EXECUTIVE SUMMARY

ES.11.1. Revised LTCP Projects and Beneficial Impacts (Update to Section ES.5 and ES.6)

Figure ES.6: Recommended Plan for CSO Control (Revised Figure ES.5)

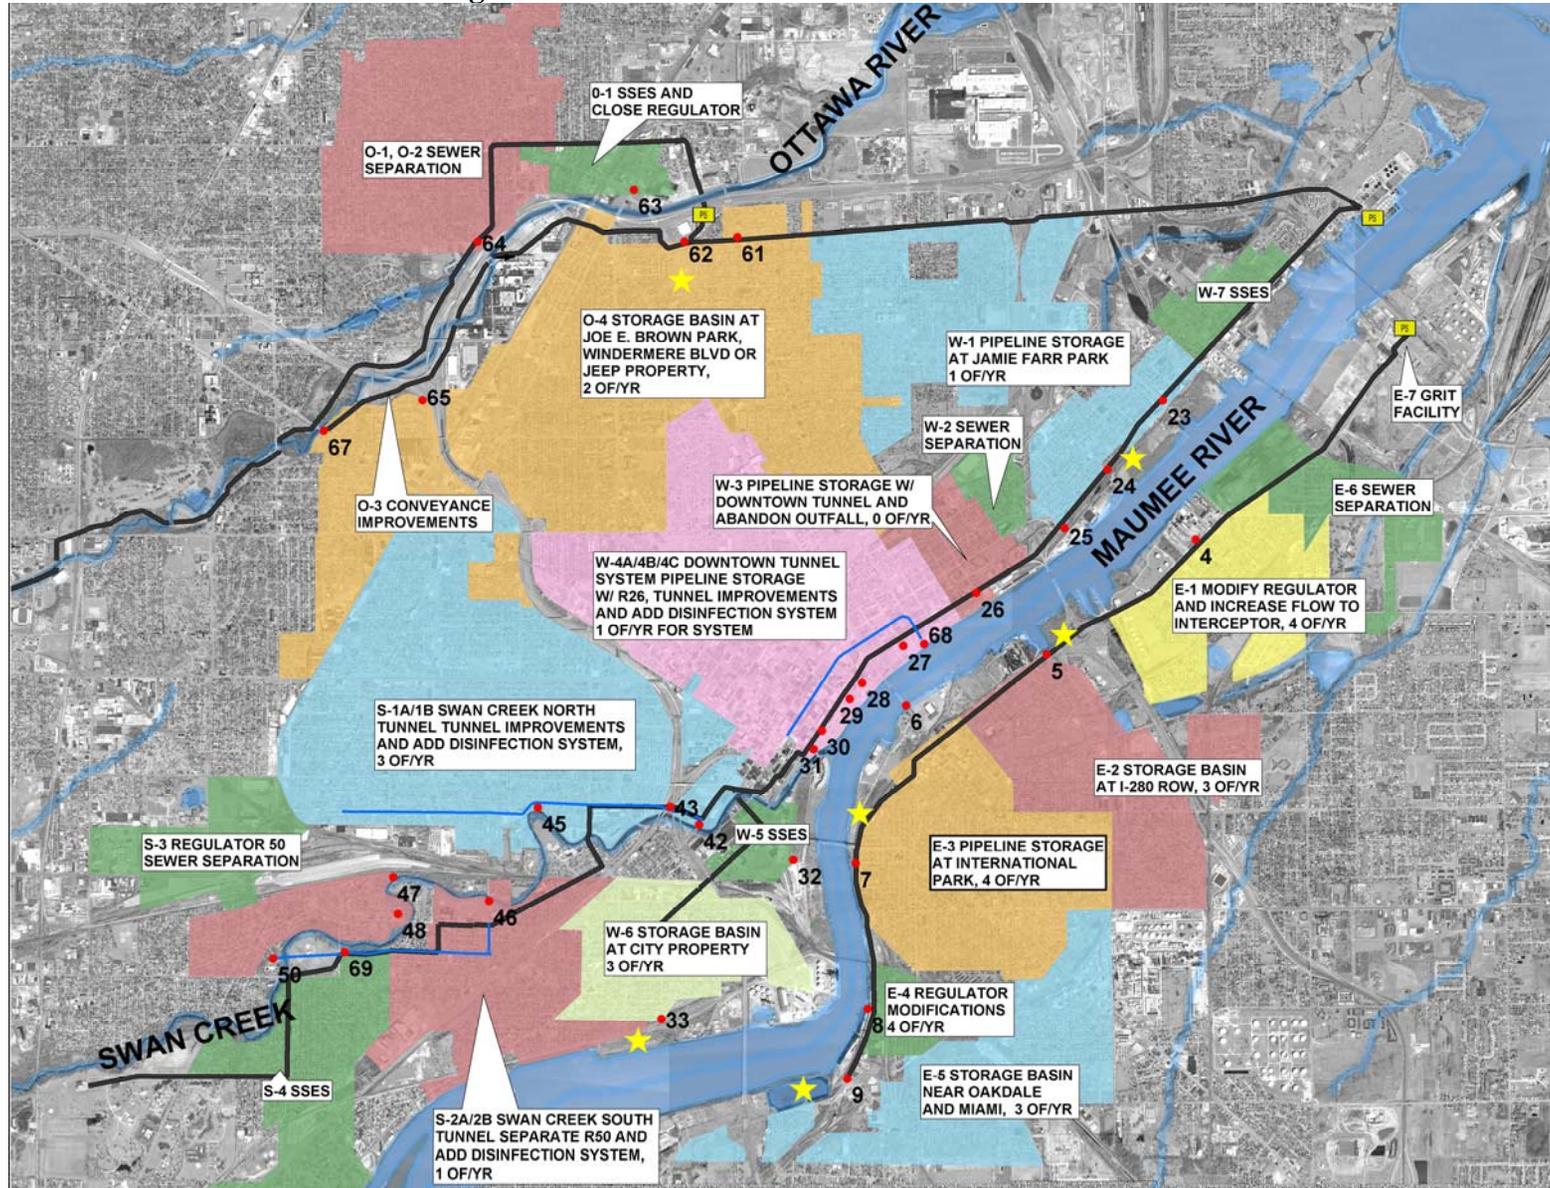
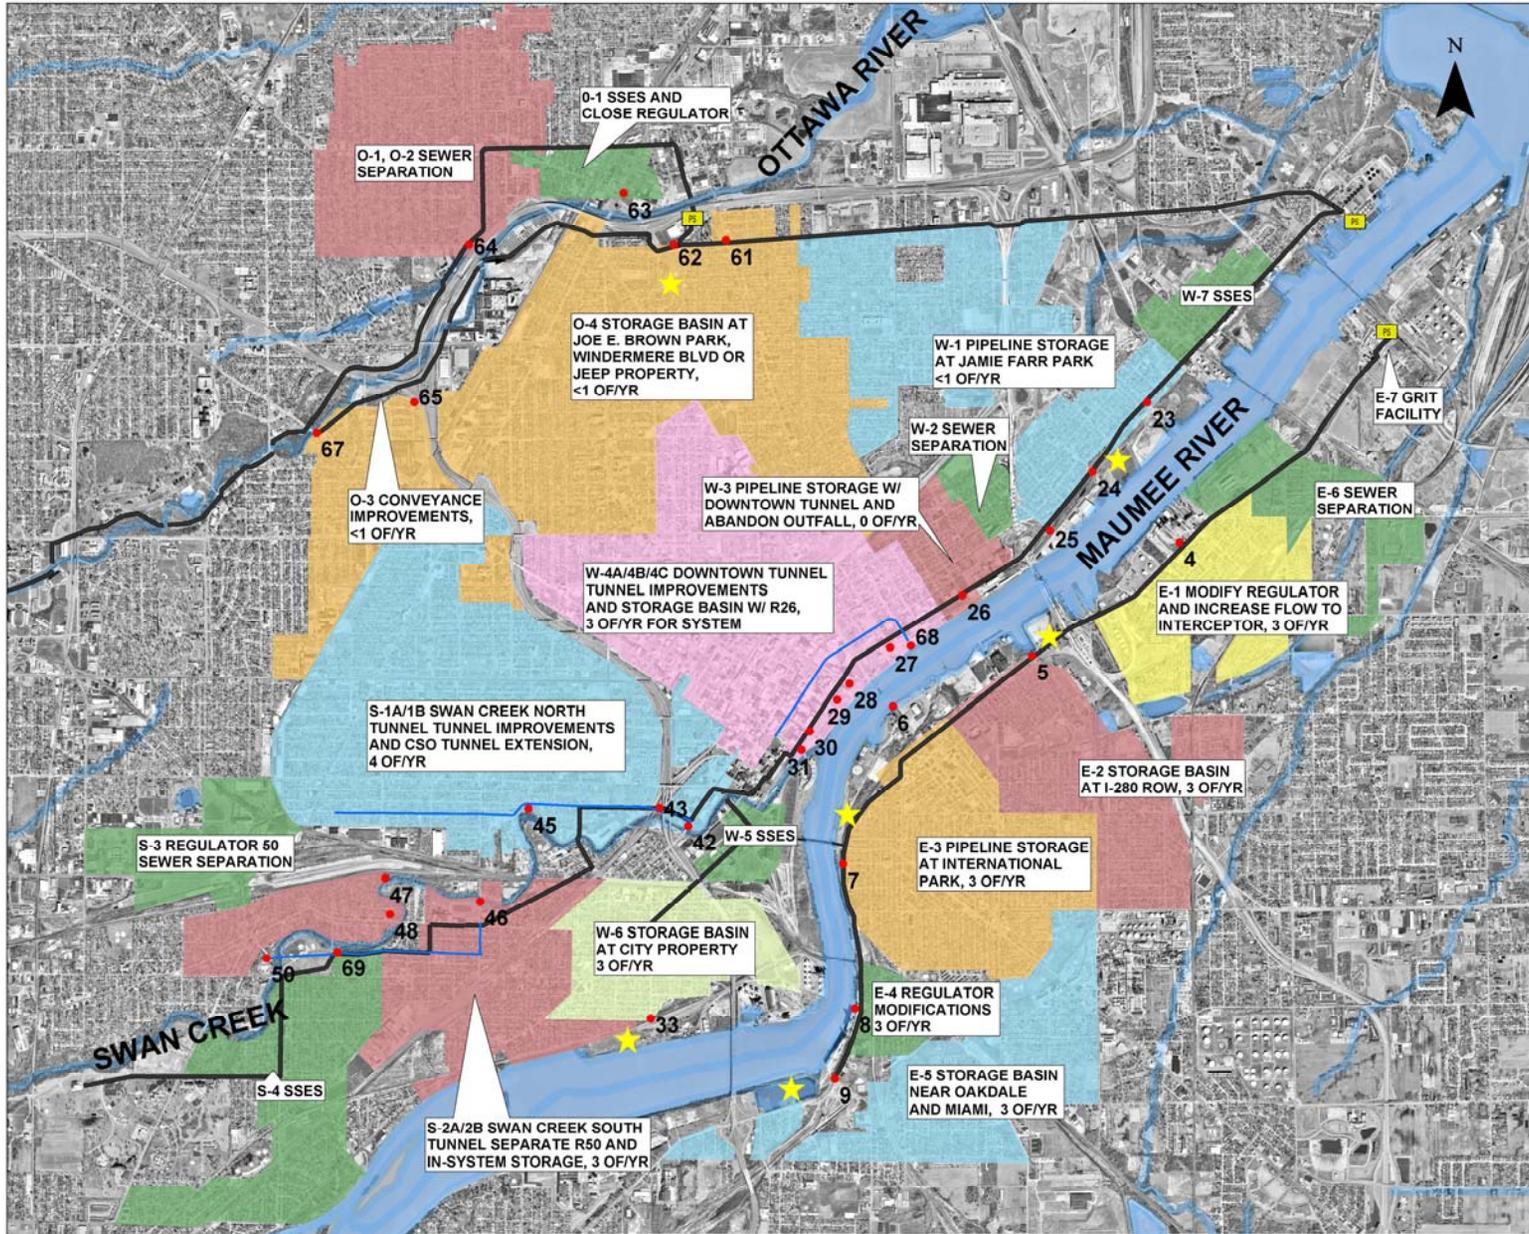
This addendum is intended to summarize changes to the LTCP that have occurred as a result of negotiations with US and Ohio EPA since the submittal of the original plan. As part of these negotiations, both the scope of the LTCP and facilities at the WWTP have been discussed. This addendum is intended to document those changes to the plan that have occurred as a result of the negotiation process.

The revised plan reflects an additional commitment by the City of approximately \$60 million toward CSO control, and it emphasizes solutions with highly predictable outcomes (storage, separation, source control) rather than solutions that rely on treatment technology that may be difficult to accomplish reliably. The 2009 LTCP includes a revised approach to evaluate the effectiveness of CSO control projects. Details of the post-construction evaluation process are presented in Section 15.6.1.

The revised LTCP projects are described in this section. Additional detail is provided in the Addendum to Chapter 13. Table ES.25 provides a summary of revised LTCP projects and costs. Figure ES.6 provides a schematic of the revised Recommended Plan.
